Application 25/02092/FP (45 Bury Mead Road)

Comments on parking and sustainable travel

Figure 1: Extract from TS Figure 6.1, showing the scope of the parking beat survey

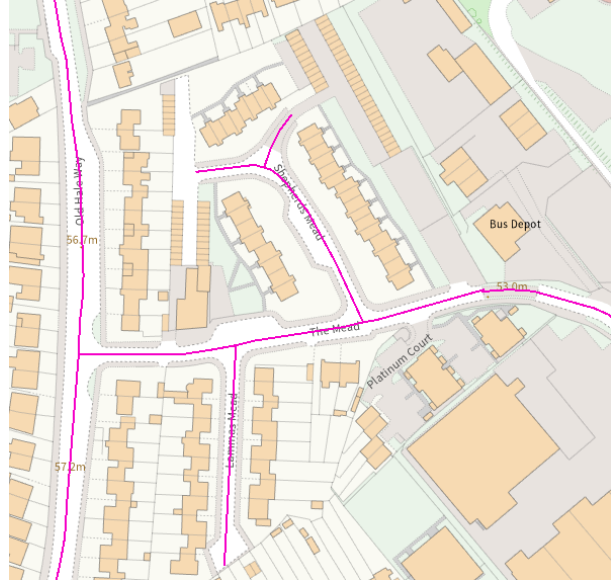
- 2.2.2 Included are areas of private land at Shepherds Mead, The Mead and Platinum Court (see Figures 1 and 2), which should not be counted as being available to the general public. Even if parking on this land is not currently controlled, the landowners or management companies could restrict access or engage private parking enforcement in future.
